TRANSMITTAL MEMO – RESUBMITTAL

Date: June 10, 2024	REQUESTS:
Item #: P24-002	The applicant is re-submitting a request for a Sketch Plan for a new 3-story, +/-290,000 sf (total habitable) mixed-use hotel and condominium development within two buildings at the following 11 properties: 45 and 65 Mercill, 330, 350, 360, and 370 N Glennwood, and 325, 335, 345, 355, and 375 N Cache St.
Planner: Tyler Valentine	For questions, please call Tyler Valentine at 307-733-0440 x 1305 or email the address shown to the left. Thank you.
Phone: 733-0440 ext. 1305	
Email: tvalentine@jacksonwy.gov	
Owners: Mogul Hospitality Partners-Jackson LLC PO Box 998 Midway, UT 84049	
Applicant: Same	
Please respond by: June 28, 2024 (with Comments)

RE: Sketch Plan Application Update: N Cache Lodging and Residential Development

RE: Miscellaneous Planning Request: N Cache Lodging and Residential Development

SITE PLAN

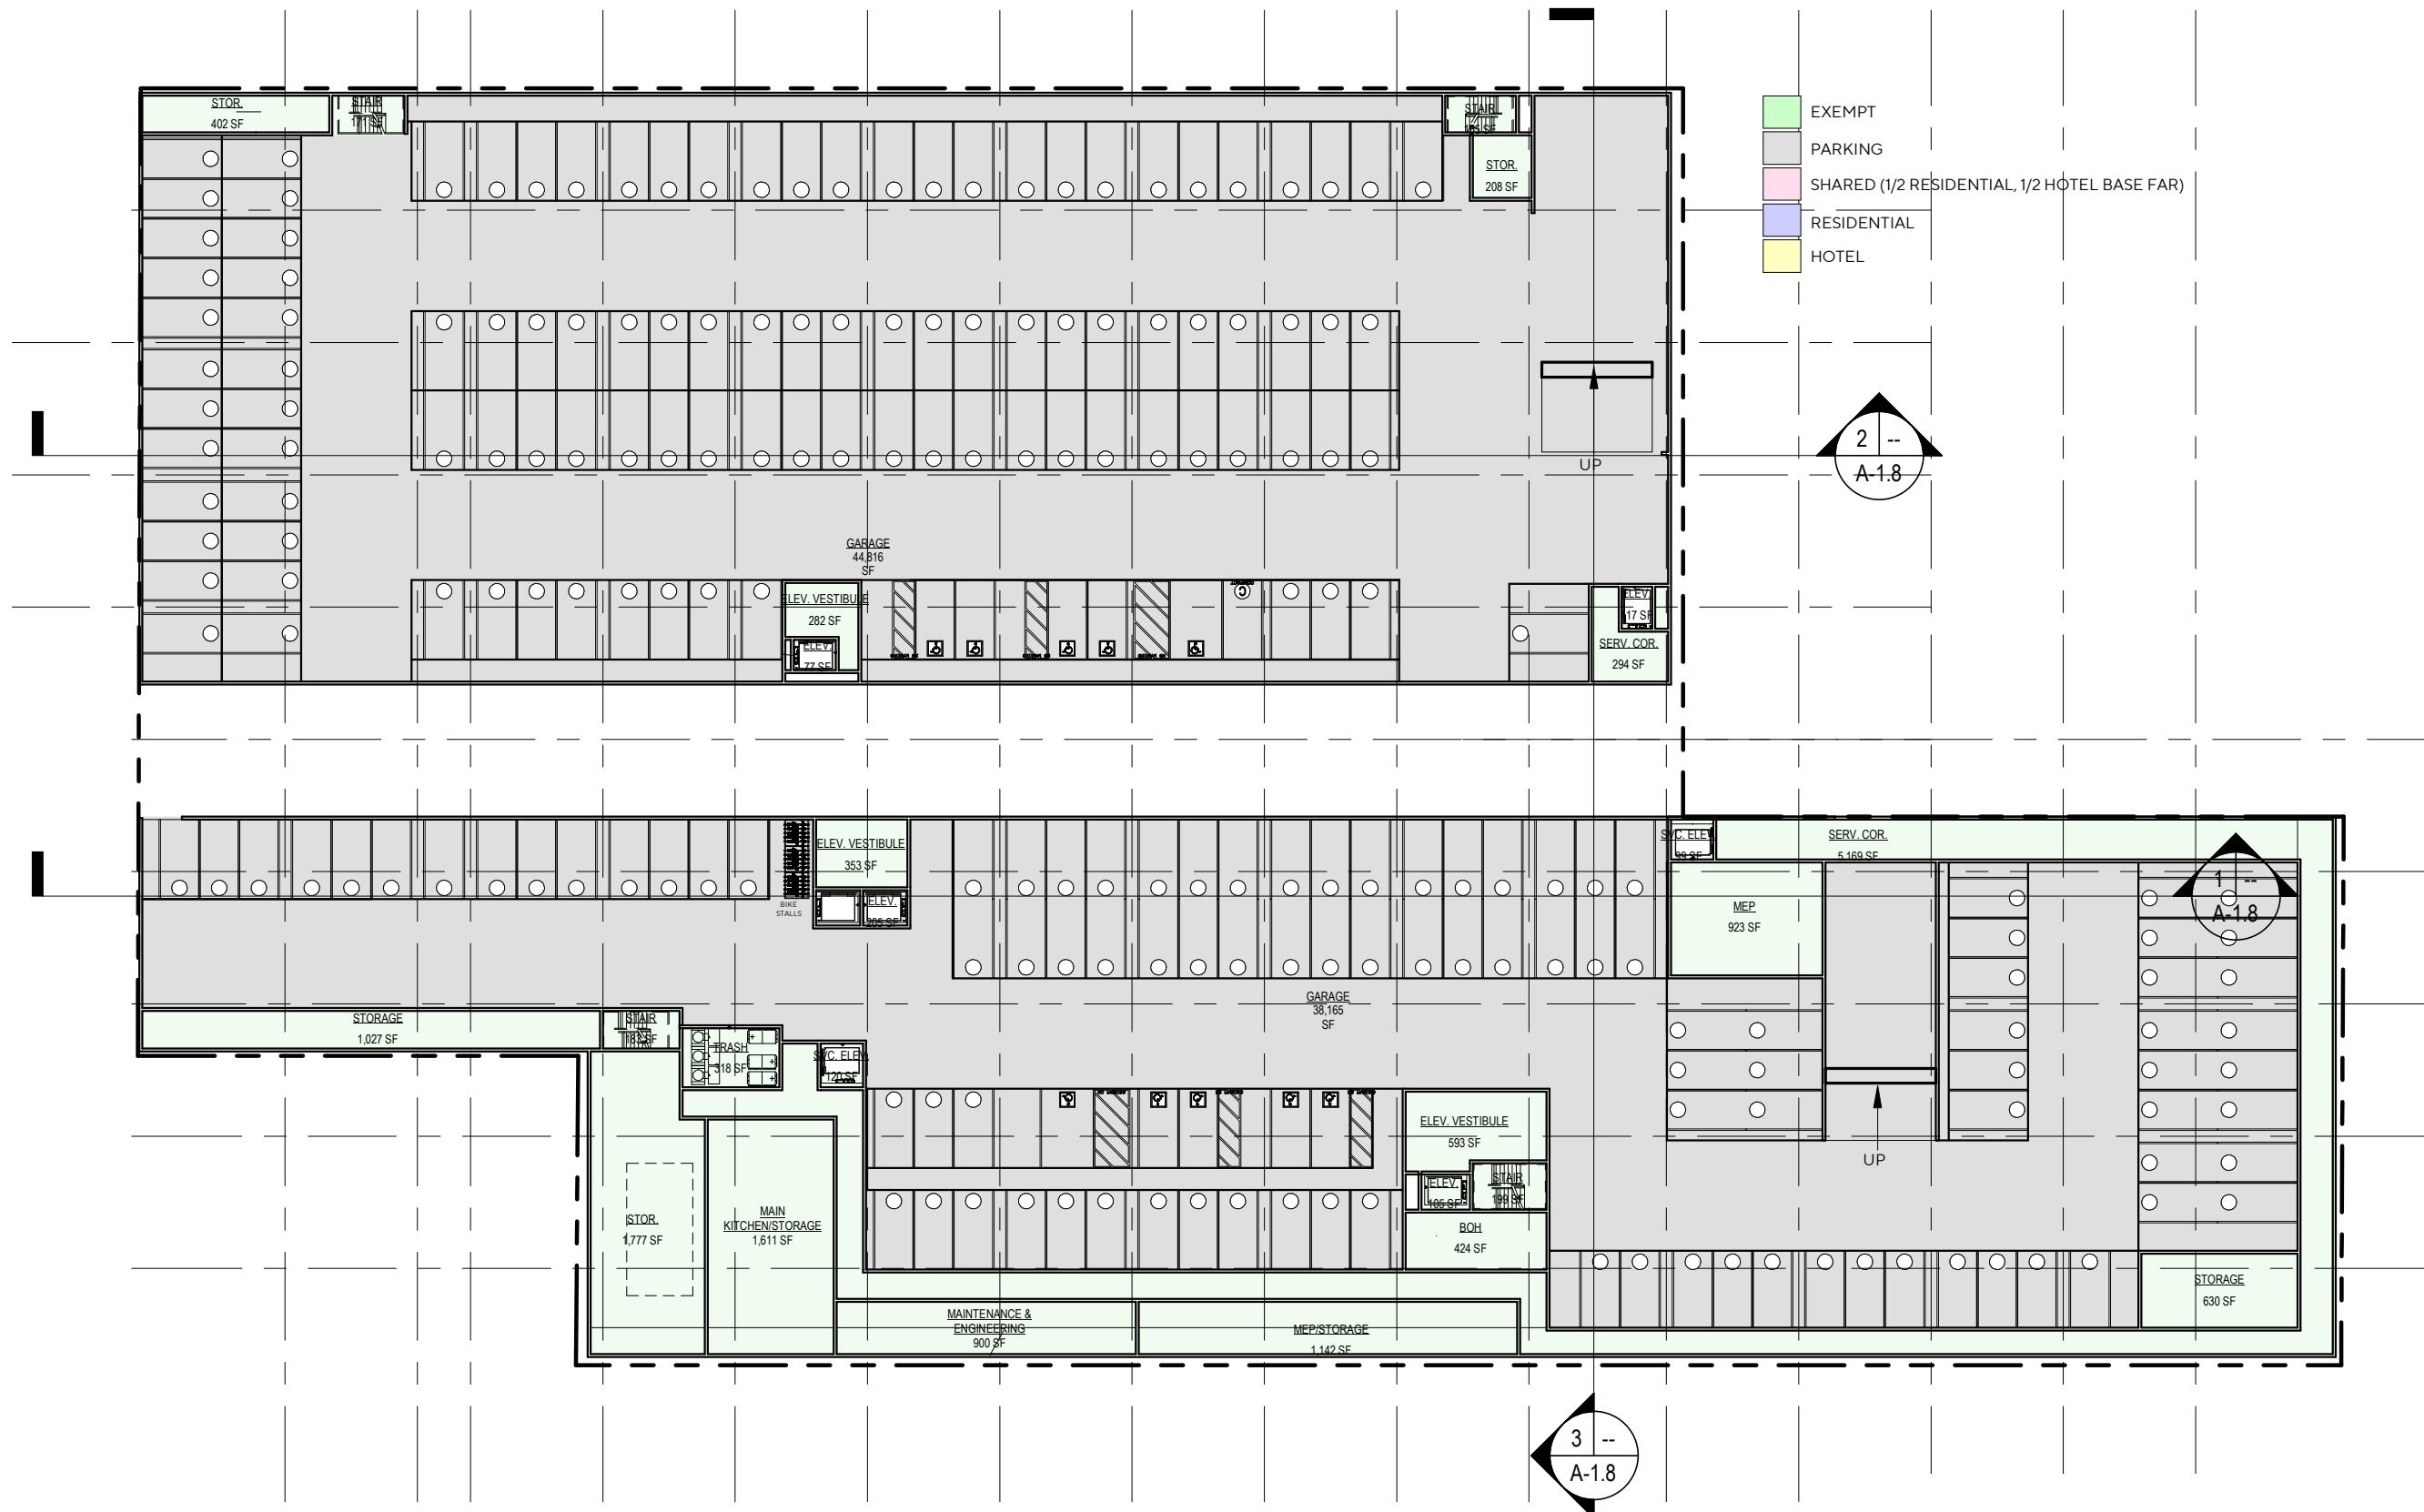
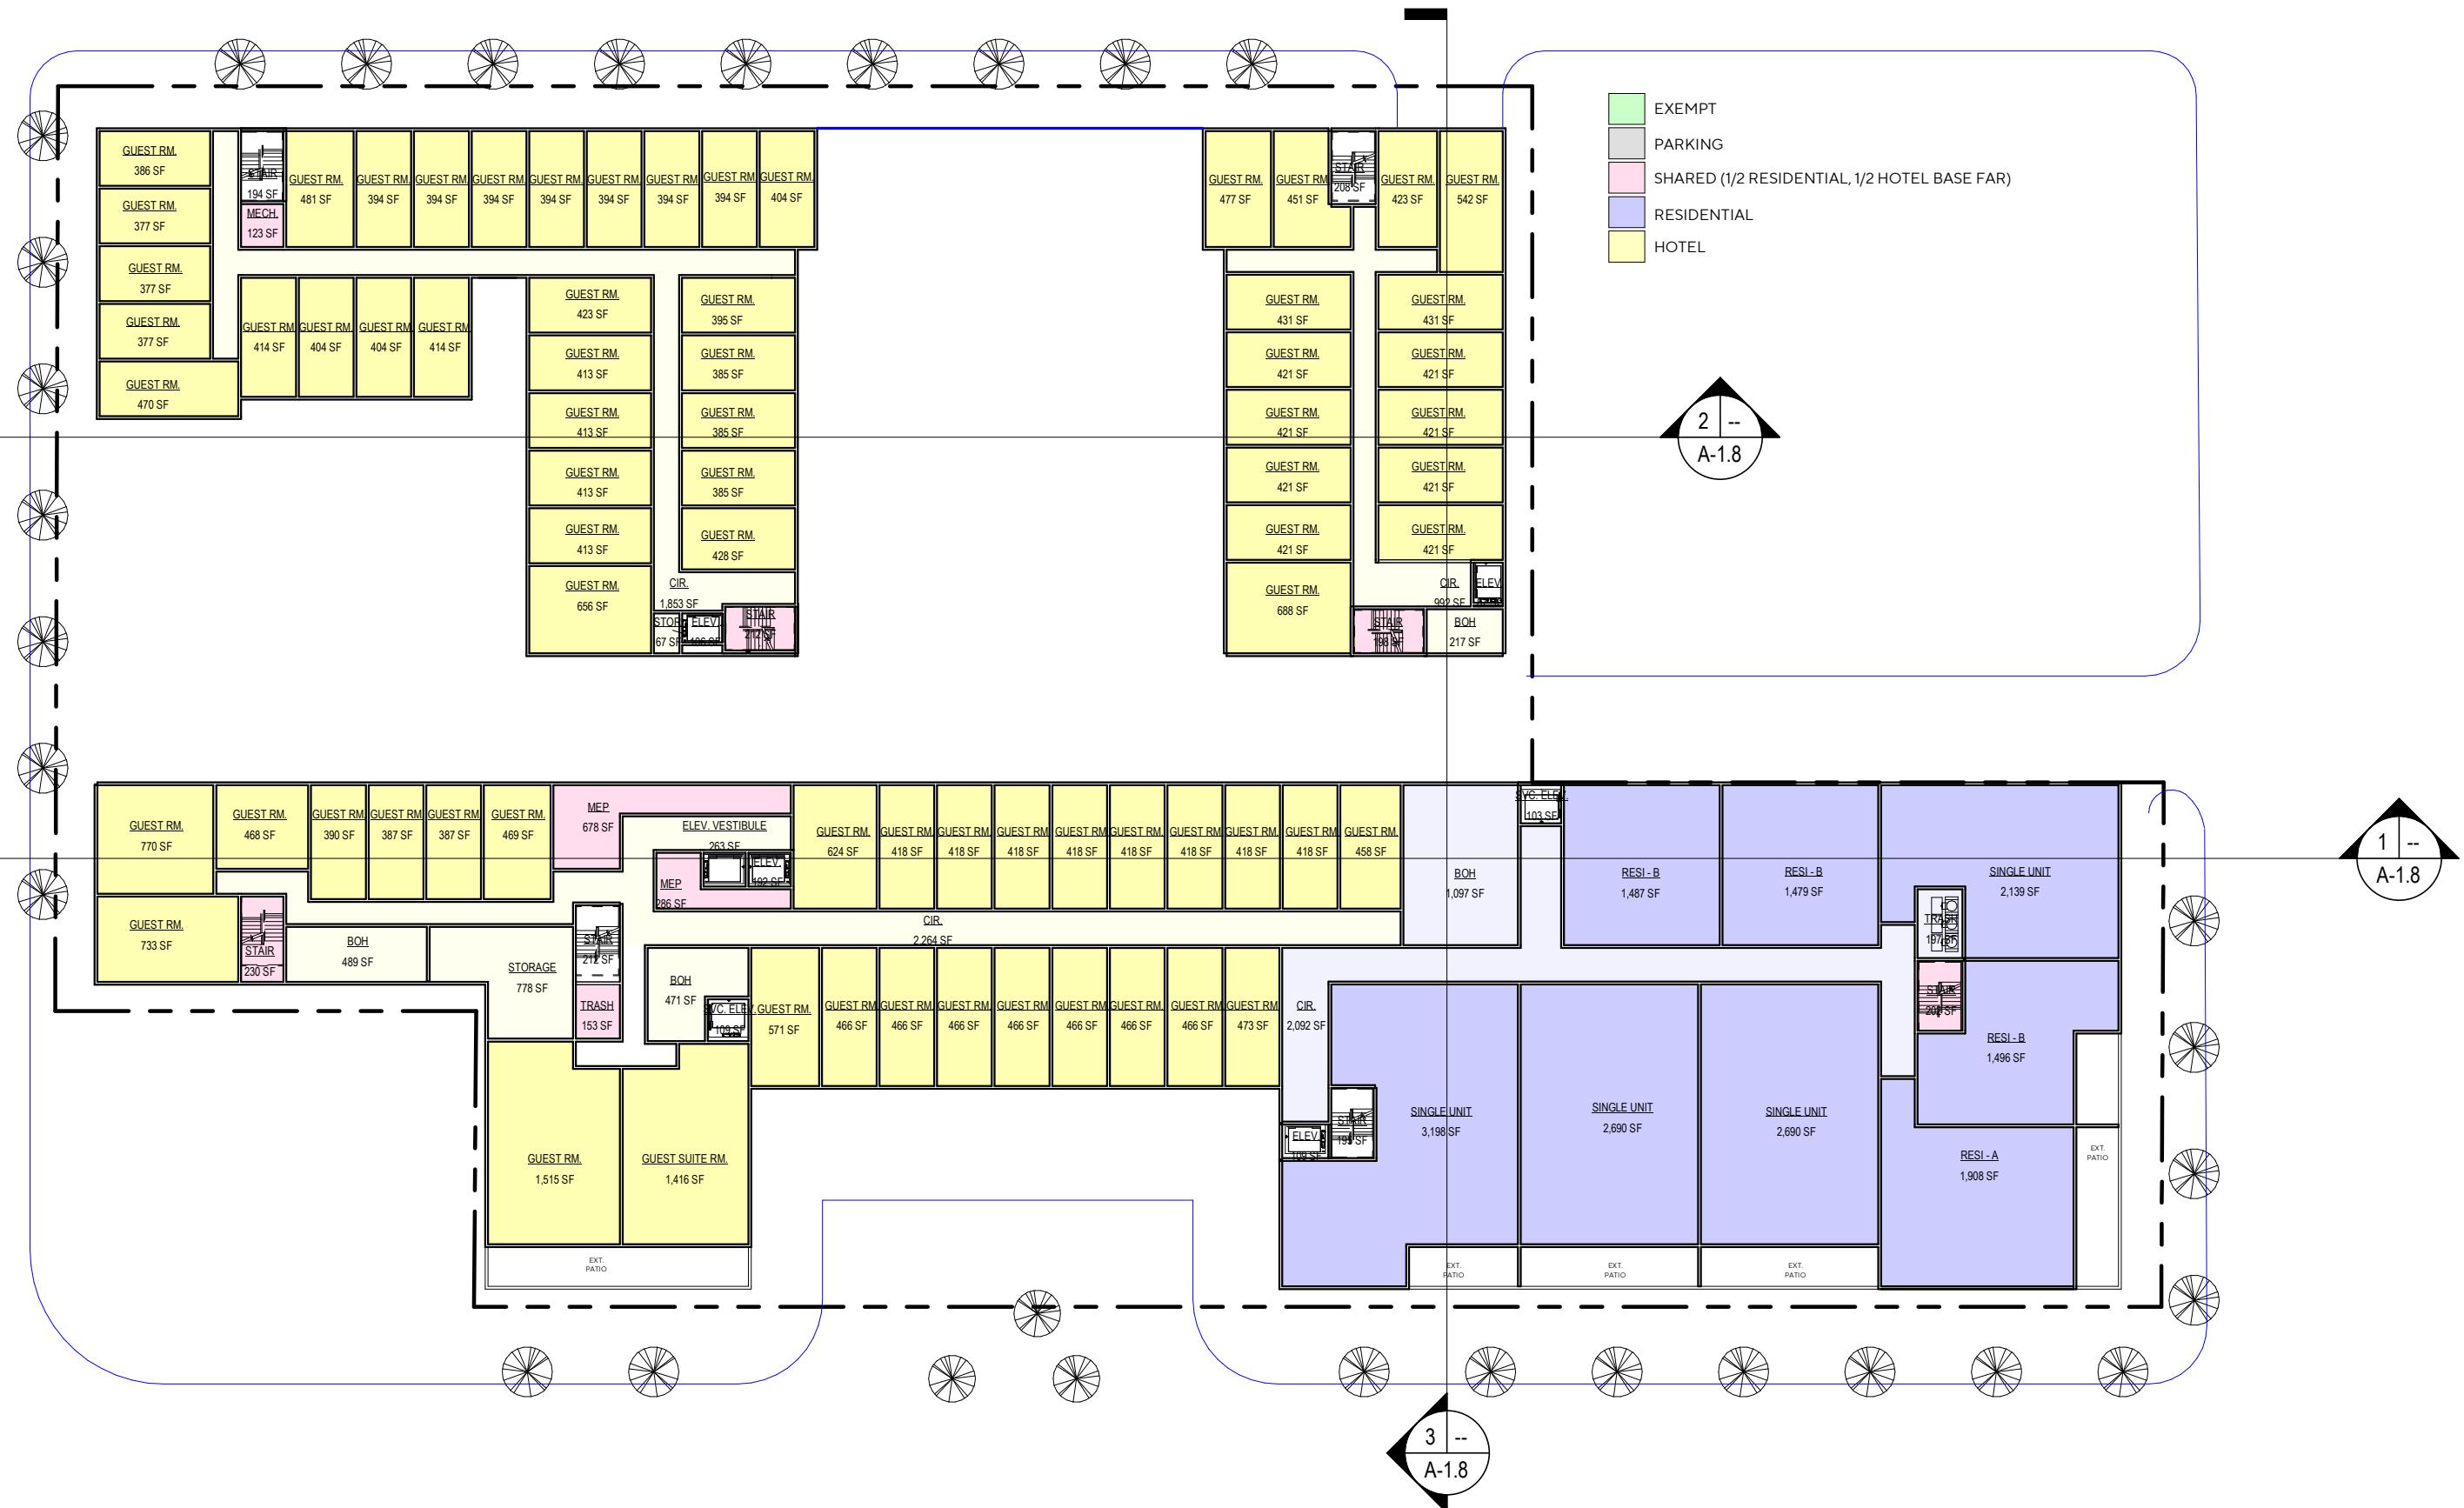
11. The proposed delivery access off of the alley does not look feasible. Provide design vehicle and maneuvering models.

- a. This is noted and will be considered in the complete Construction Management Plan further in the design and approval process.
17. There is no separation between the alley and parking garage entrance. Relocate the parking garage entrance or explain how traffic conflicts will be mitigated between the two access points.

- a. The alleyway and its invitingness will improve with the planned design, please find this addressed in the attached.
7. ACCESS - Need to discuss the maximum 24 curb cut standard and the 30 primary street surface parking/circulation setback.

- a. Please find attached a plan set that addresses this comment.

- a. Please find attached a plan set that addresses this comment.
18. Provide estimated water demands, sewer volumes, and stormwater quantities and information regarding whether or not they have an impact on Town utilities.

- a. Please reference attached plan set.
8. CACHE CREEK MOTEL - The applicant shall engage with the owners of 390 N. Glenwood (Cache Creek Owner LLC) to ensure that their concerns are addressed in any alley vacation scenario.

Parking Management Plan

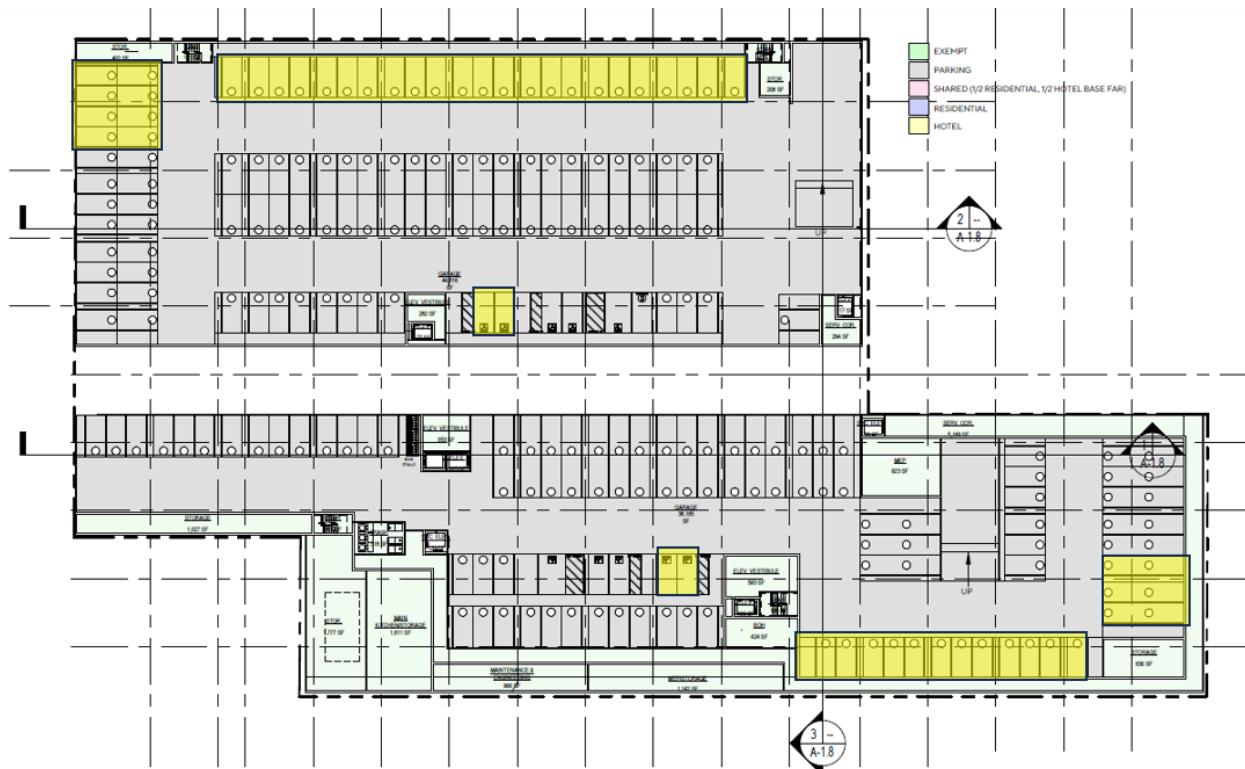
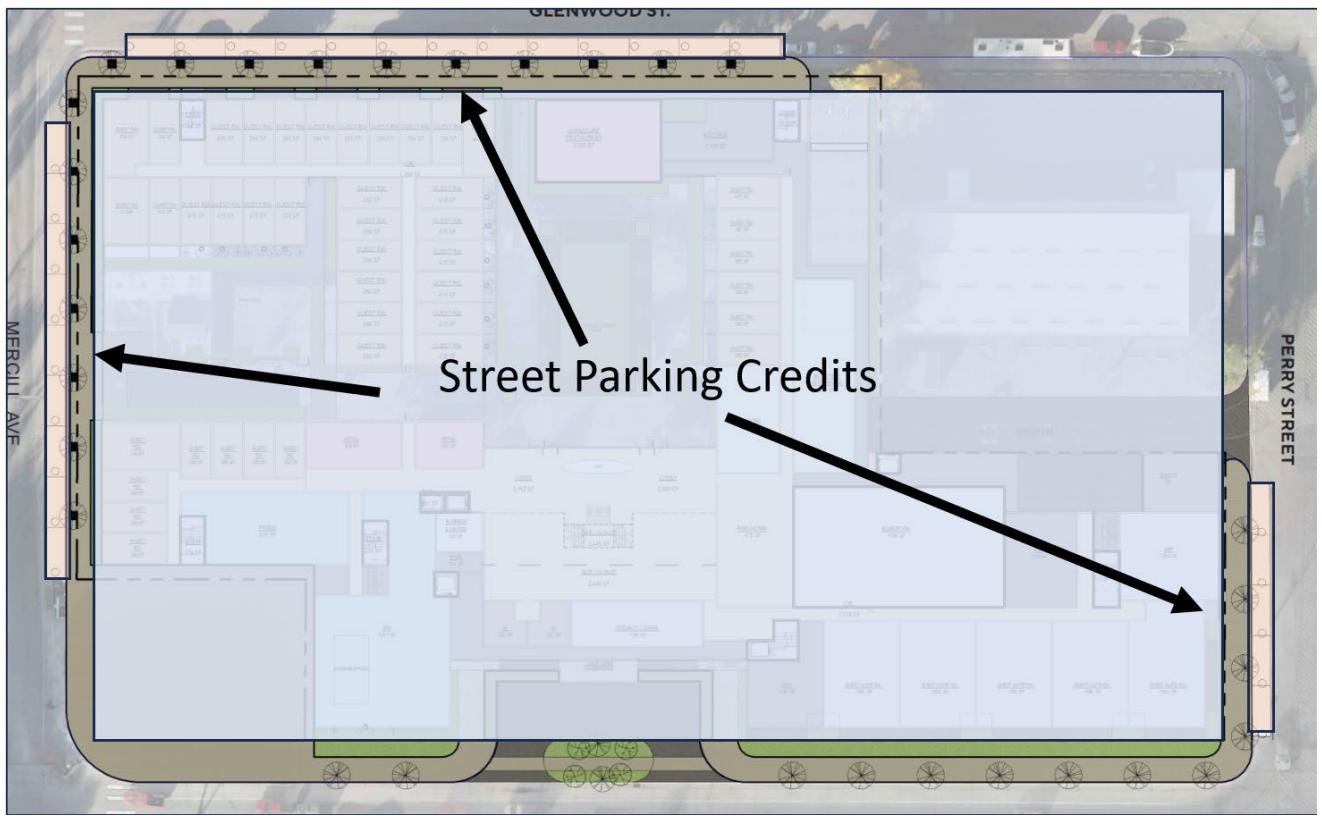
- a. Please reference attached updated plan set which incorporates.
- 17. PARKING REQUIRED - Need clarification on the amount of parking required. The commercial / restaurants do not appear to be factored into the requirements. In addition, staff did not find any historical parking credits tied to any of the subject properties. Also, is the hotel parking managed via valet parking?

- a. Please reference attached plan set which includes the parking requirements against the parking provided. The hotel will offer valet parking for guest, condo owners, and public who visit the Project's amenities.
